Original Application No. 39 of 2020(SZ)

REPORT OF THE IRRIGATION DEPARTMENT BY THE 3rd RESPONDENT

Sub: Submission of plans for construction of box type storm water drain, situated at the development site in Survey Nos. 285, 286 and 287 of the Puppalaguda Village, leading from the culvert to the Bulkapur Channel- Approval -reg

Plan showing box type storm water drain, situated at the development site in Survey Nos. 285, 286 and 287 of the Puppalguda Village, Gandipet mondal, RR dist leading from the culvert to the Bulkapur Channel
SCALE: NTS
REV: R0, DATE: 12-02-2023

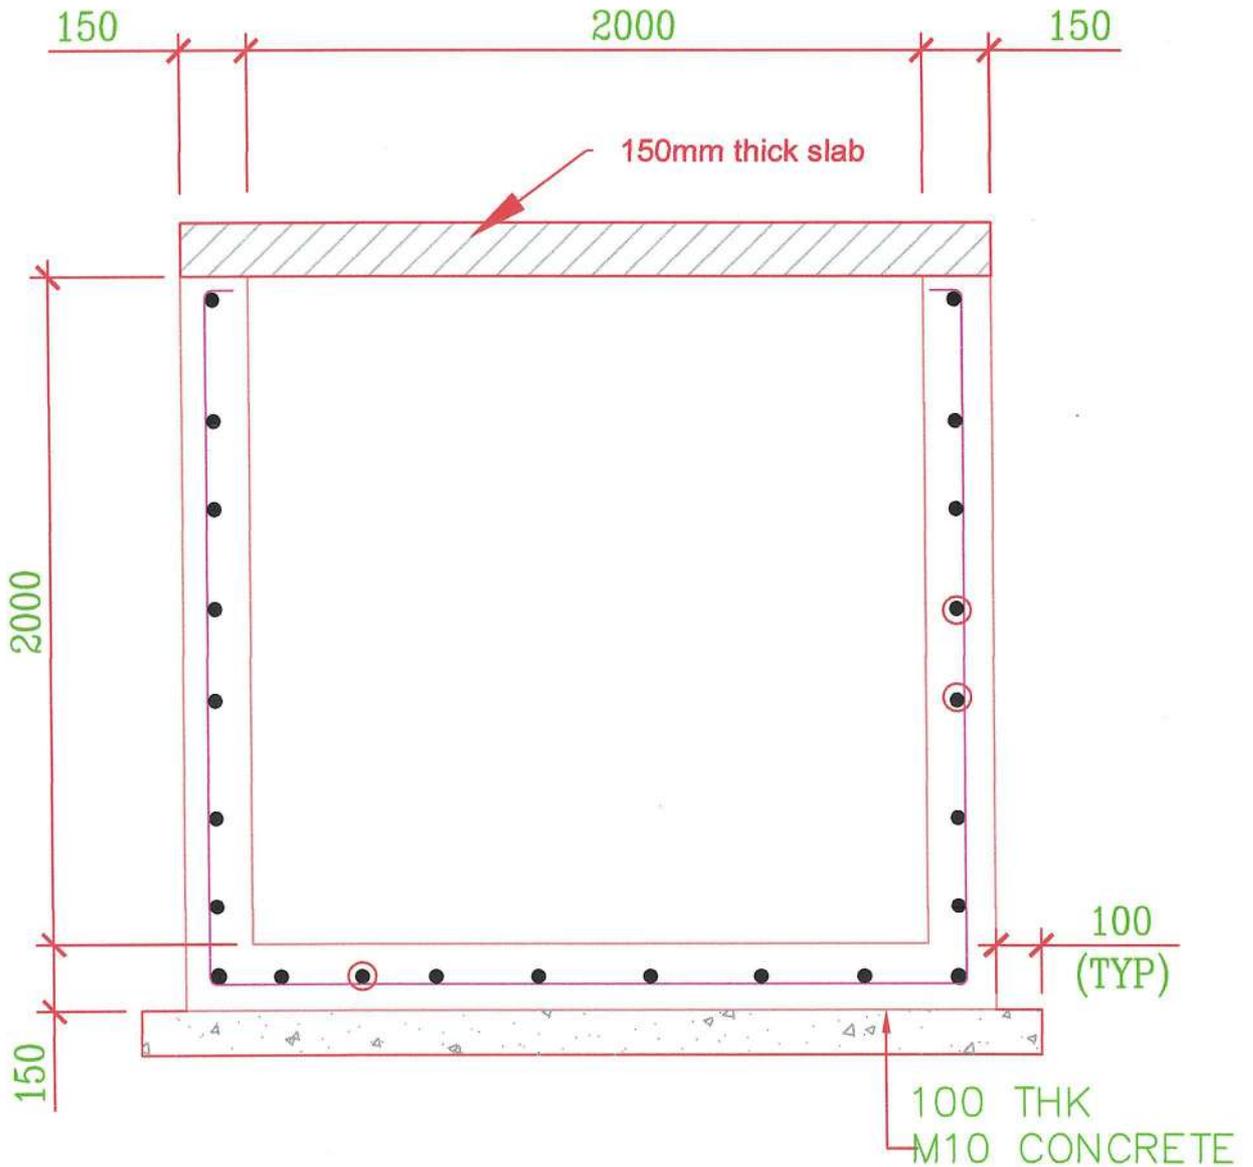
5. **Rainfall with 100mm per hour with peak runoff is categorized as cloud bursts.** Catchment area is worked out & based on the above the discharge is arrived and correlate with the proposed storm water drain from the existing culvert portion to the Bulkapur Nala. As the Respondent No.9 have proposed storm water drain with **1500mm x 1500mm is not sufficient to carry the water** (Copy of application enclosed, Annexure - III) in cloud bursts situation in present condition. The same is informed to the Project Proponent.

Rejected the proposals, as the proposed section is not sufficient to carry the Flood discharge

6. Based on the hydrology, technically it is feasible to re-align the stream from North east of the project proponent land leading towards southern side and connected into the Bulkapur Nala in South East side. The Box-type storm water drain size should be 2000mm x 2000mm to accommodate the maximum flood discharge even in Cloud bursts situation for the mentioned 1st order stream from the Existing culvert to the Bulkapur Nala.

PROPOSED CROSS SECTION OF STORM WATER DRAIN FROM THE EXISTING CULVERT TO BULKAPUR NALA

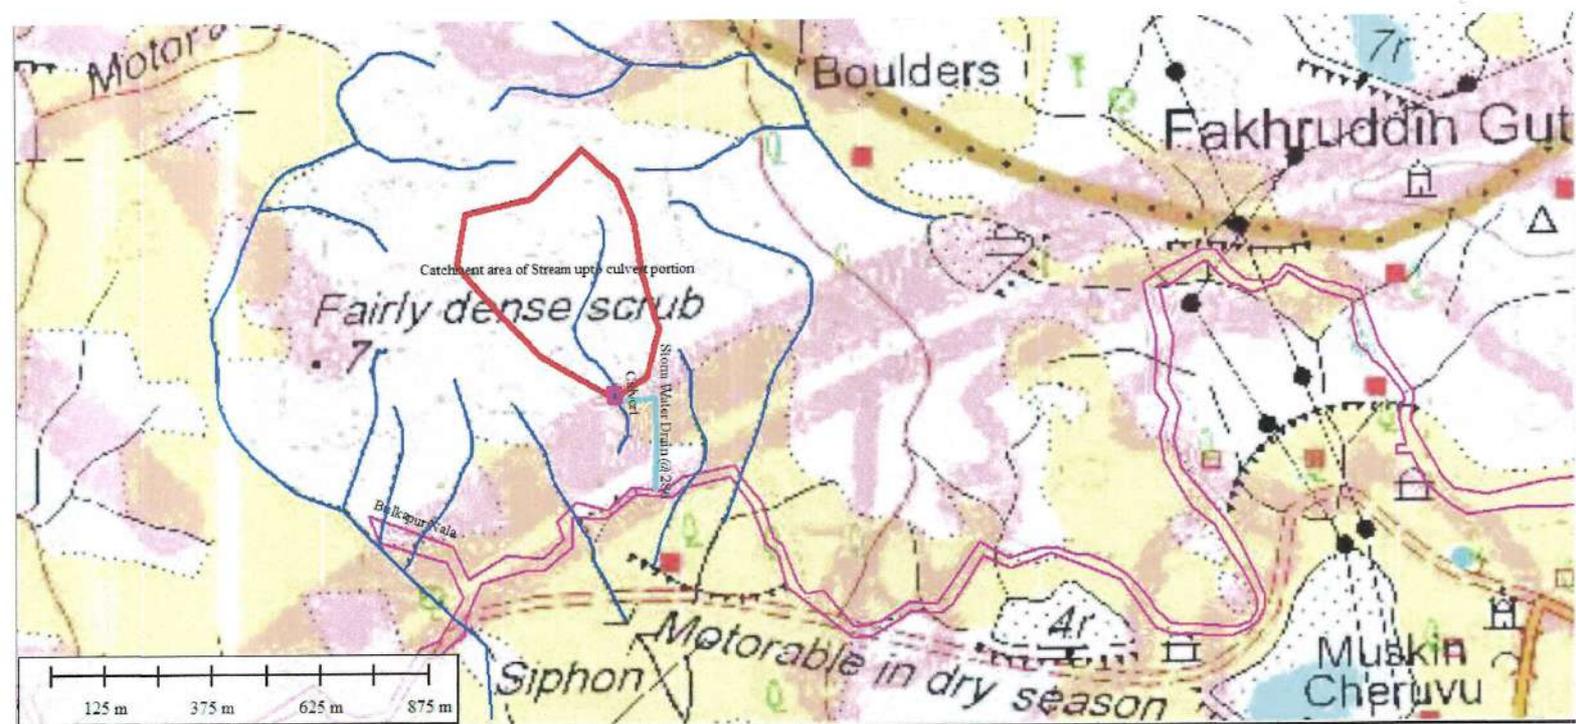
7. The necessary calculations & cross section of the proposed box type-drain for the mentioned 1st order stream is enclosed for taking further necessary action (Annexure - IV & V). The same is communicated to the **M/s Phoenix Spaces Private Limited** and instructed to construct a box-type drain for storm water with 2000mm x 2000mm size for disposal of flood water during the rainy season and even in cloud bursts condition duly keeping the following conditions:

Hence, Proposed Section for Storm Water Drain is:**2000mm X 2000mm**
